World Forum for Harmonization of Vehicle Regulations

Proposal for Supplement 13 to the original series of amendments to UN Regulation No. 45 (Headlamp cleaners)

Submitted by the Working Party on Lighting and Light-Signalling*

Diagram of Measuring Points on a Screen

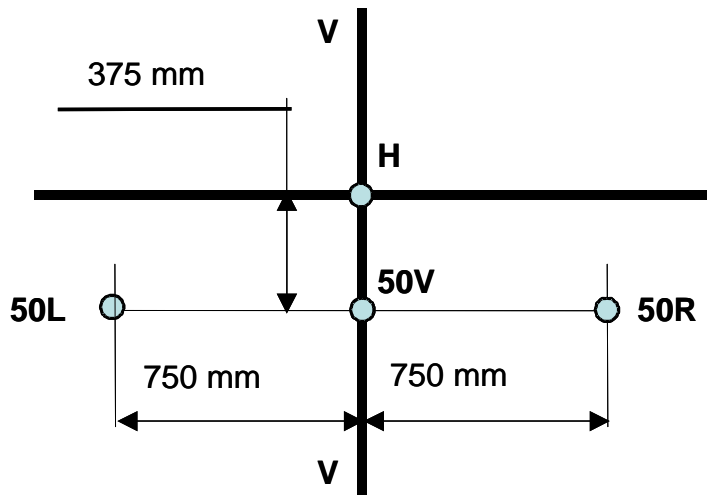
Paragraph 7.1., amend to read:

"7.1. The efficiency of the cleaner shall be tested in accordance with the requirements of Annex 4 to this Regulation. The cleaning efficiency at the points on the measuring screen which are specified below shall, after every cleaning period, amount to at least 70 per cent for the principal passing beam lamp and also 70 per cent for the optional driving lamp; in case of an AFS this provision applies to the photometric test procedures as defined in Annex 9 to UN Regulation No. 123 or in Annex 4 to UN Regulation No. 149 from those lighting units in the neutral state indicated in paragraph 6.1.1. above. In the case of a headlamp (UN Regulations Nos. 98, 112 or 149) providing bend lighting, the headlamp shall be set for the test in a straightforward direction.
